RE: Harper College Project No. Q01151
2024 Sidewalk & Concrete Maintenance
Addendum #1

Please refer to the attached and below items regarding the proposed 2024 Sidewalk & Concrete Maintenance project by Harper College (project no. Q01151), which comprise **Addendum #1**. The Bid Documents for the project, dated March 28, 2024, shall be formally revised as described herein. Revised text in the Project Manual is denoted by ***bold-italics***; omitted text is denoted by ~~***bold-italics***~~. Receipt of this Addendum must be acknowledged by all prospective bidders within the applicable section on the Bid Form; failure to acknowledge receipt may result in disqualification of the bid.

HARPER COLLEGE PROJECT NO. 001151
2024 SIDEWALK & CONCRETE MAINTENANCE
 1200 W Algonquin Rd.
 Palatine, IL

SHEET NUMBER
C1.11
 8 OF 14

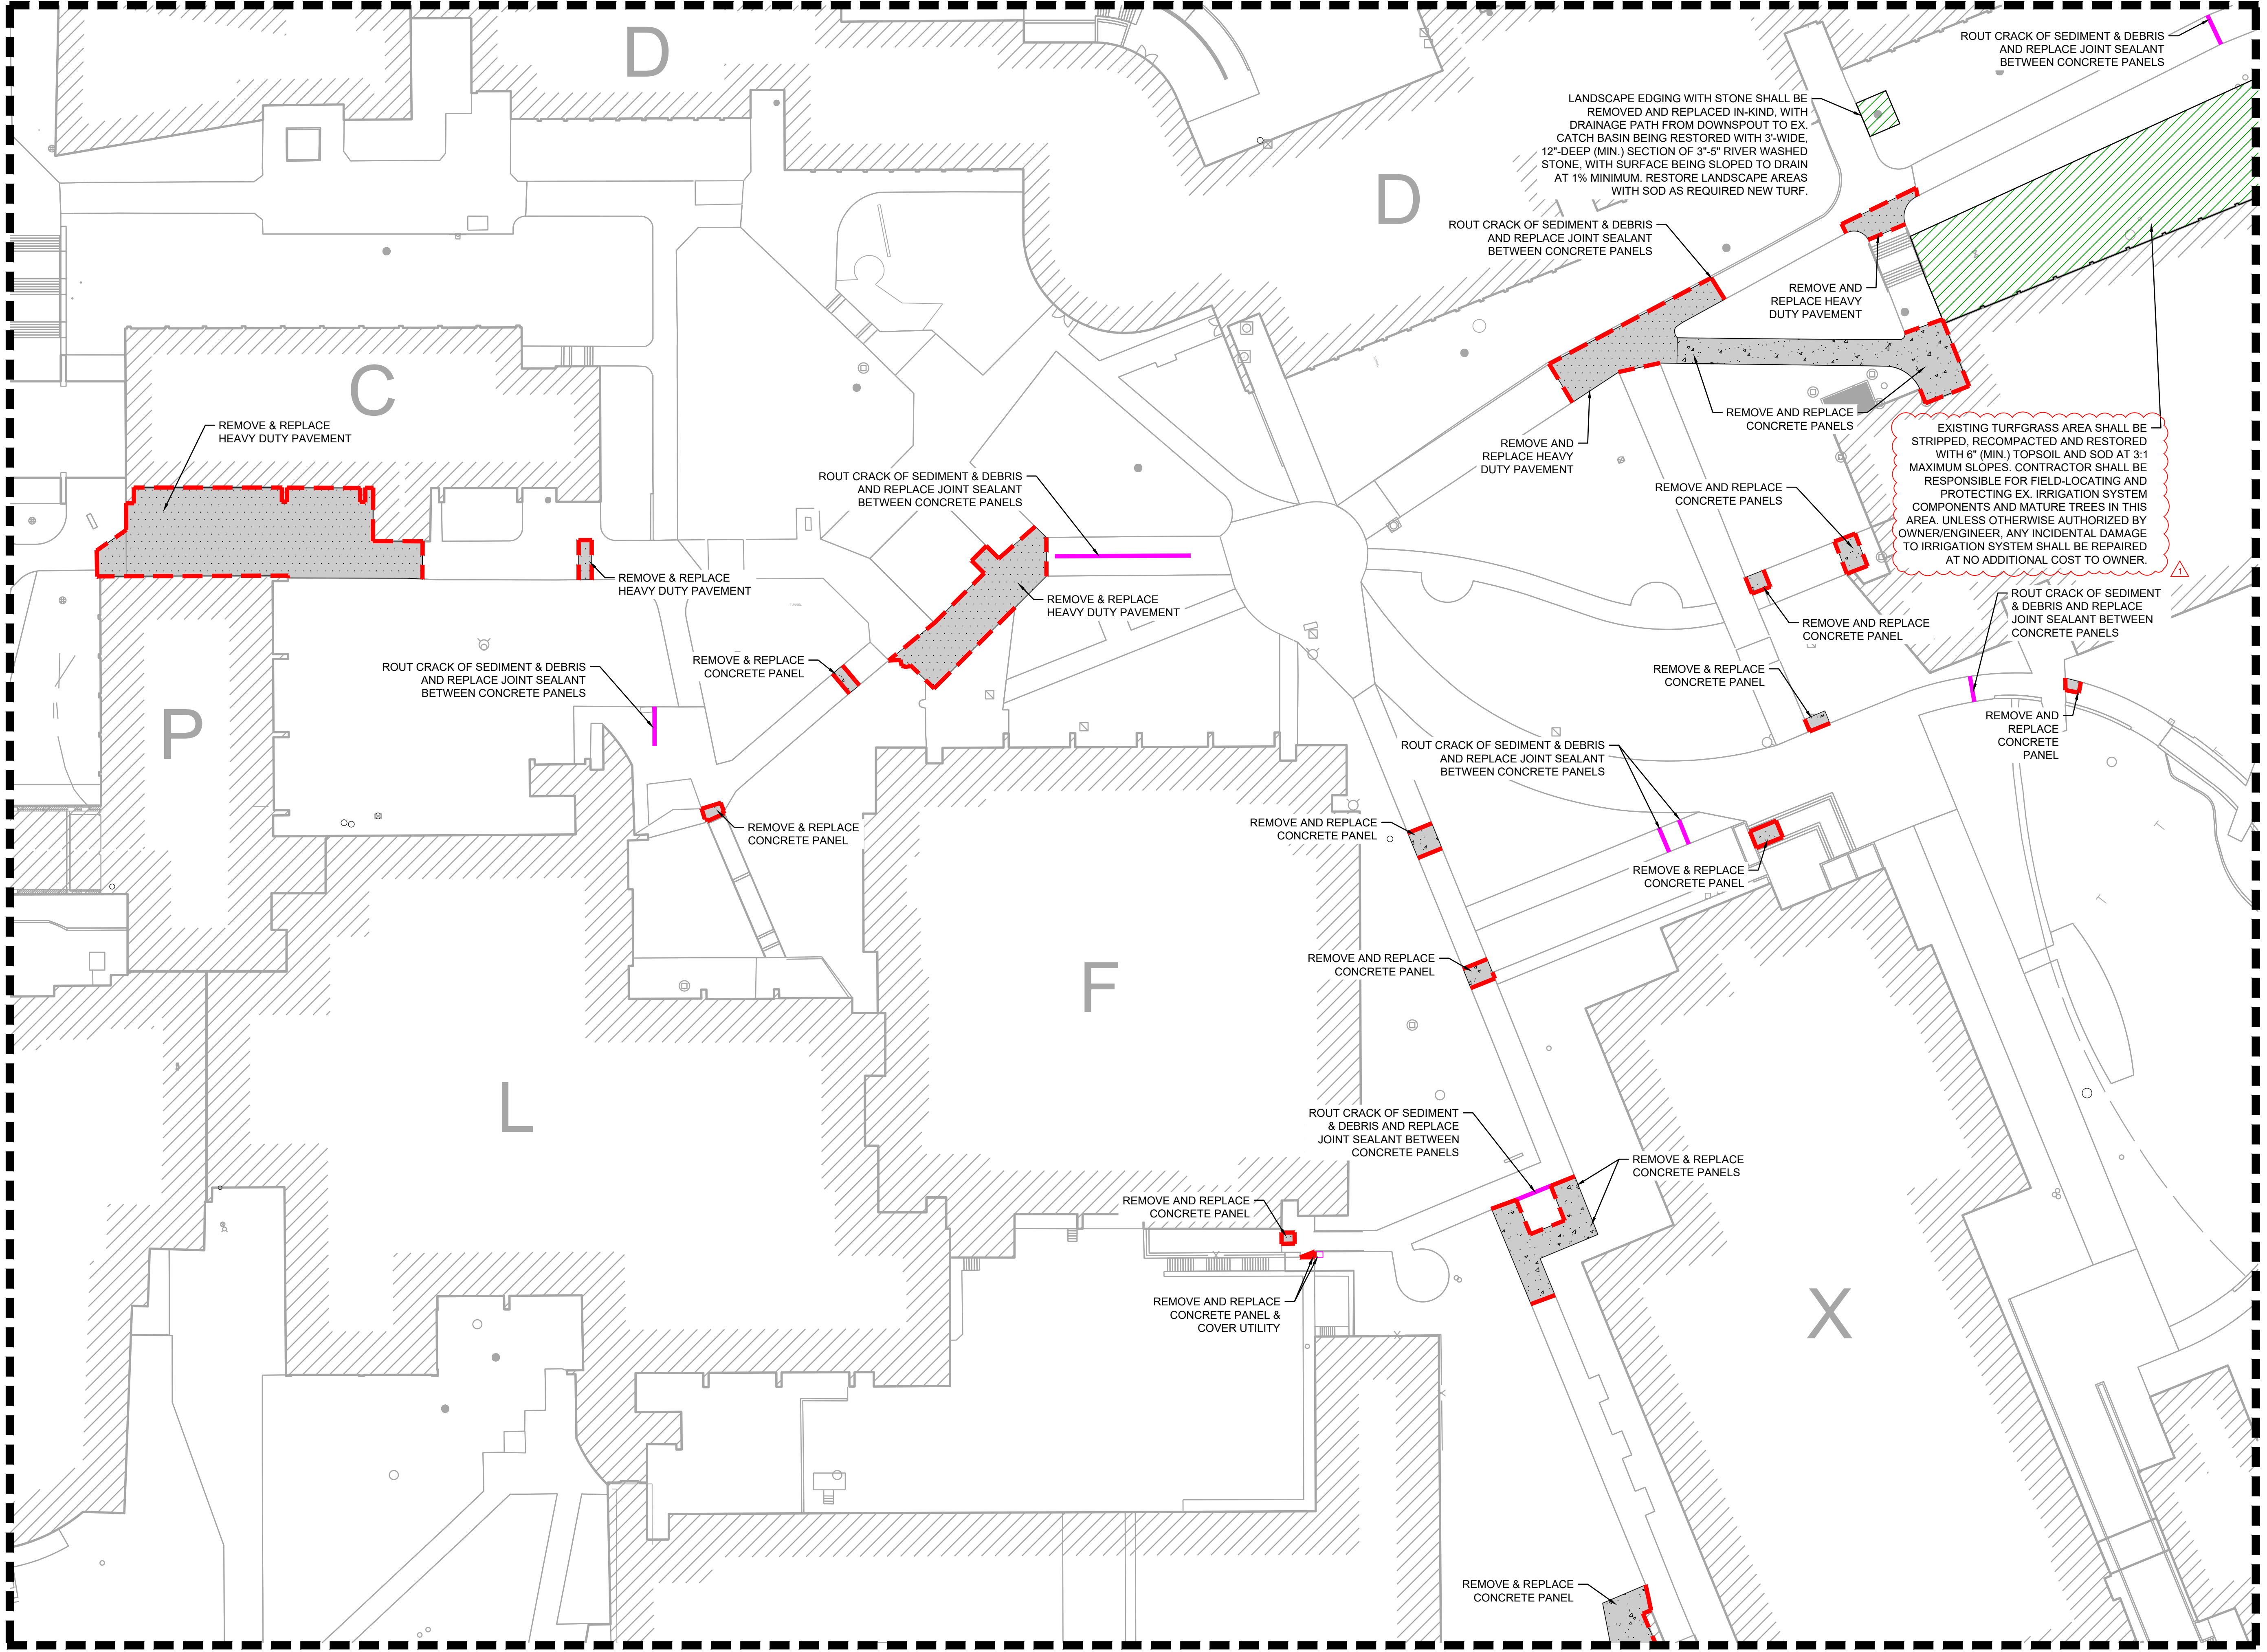
4. Regarding the proposed landscape area stripping and restoration indicated on sheets C1.11 and C1.12 (on the north side of Building H on the main campus), are there existing irrigation lines in place in that area? If so, how should those lines be addressed as part of the proposed work?

Sheets C1.11 and C1.12:

1. Clarify that existing irrigation system components in landscaped turf area shall be field-located and protected, with any incidental damages being repaired at no additional cost to Owner.

Response: There are existing irrigation lines in this area of work; additional notes have been added to sheets C1.11 and C1.12 to clarify how the existing irrigation shall be accommodated.

EXISTING TURFGRASS AREA SHALL BE STRIPPED, RECOMPACTED AND RESTORED WITH 6" (MIN.) TOPSOIL AND SOD AT 3:1 MAXIMUM SLOPES. CONTRACTOR SHALL BE RESPONSIBLE FOR FIELD LOCATING AND PROTECTING EX. IRRIGATION SYSTEM COMPONENTS AND MATURE TREES IN THIS AREA. UNLESS OTHERWISE AUTHORIZED BY OWNER/ENGINEER, ANY INCIDENTAL DAMAGE TO IRRIGATION SYSTEM SHALL BE REPAIRED AT NO ADDITIONAL COST TO OWNER.

C3.0

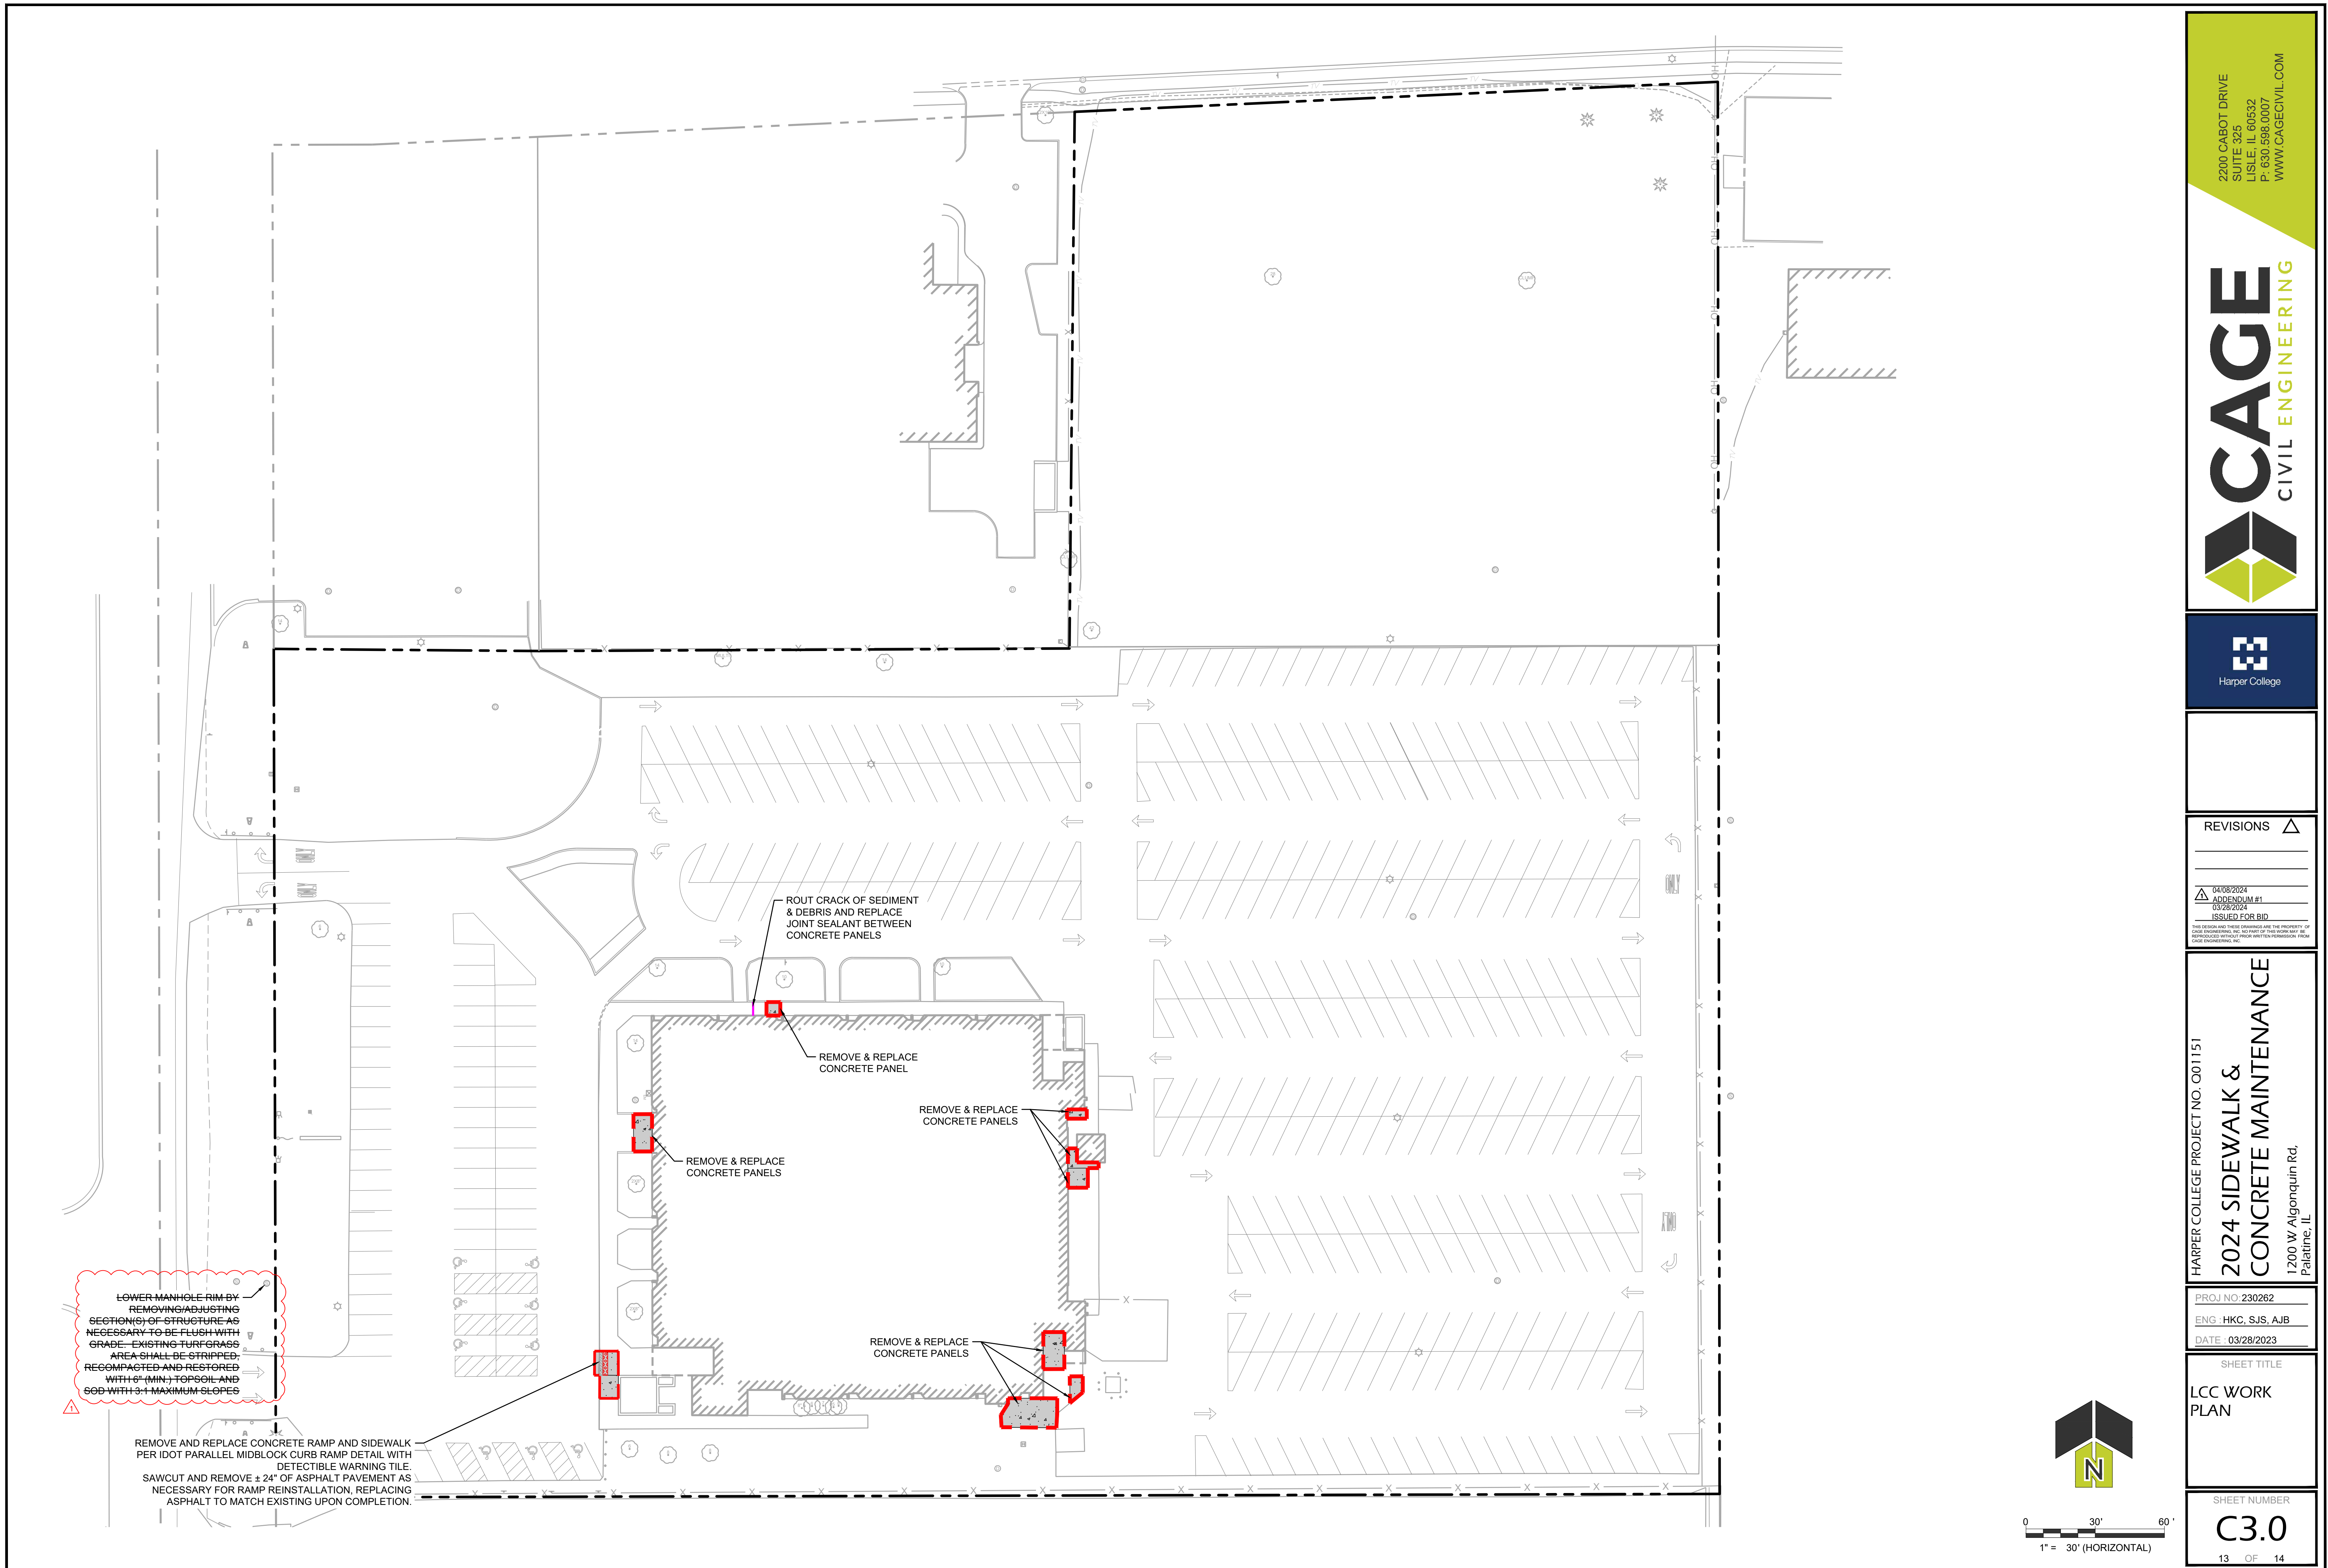
Sheet C3.0:

1. Omit manhole structure adjustment and associated regrading/landscape restoration in South Wolf Road public right-of-way to west of site.

5. Please confirm that there are no modifications to the existing sewer connections being proposed as part of the utility structure rim adjustments as indicated on sheets C1.11, C2.0, and C3.0.
Response: Confirmed; there are no proposed modifications to the existing sewer pipe connections at these structures, only the structures themselves. Please also note that the sanitary manhole modification which was previously indicated on sheet C3.0 has been omitted from the scope of work.
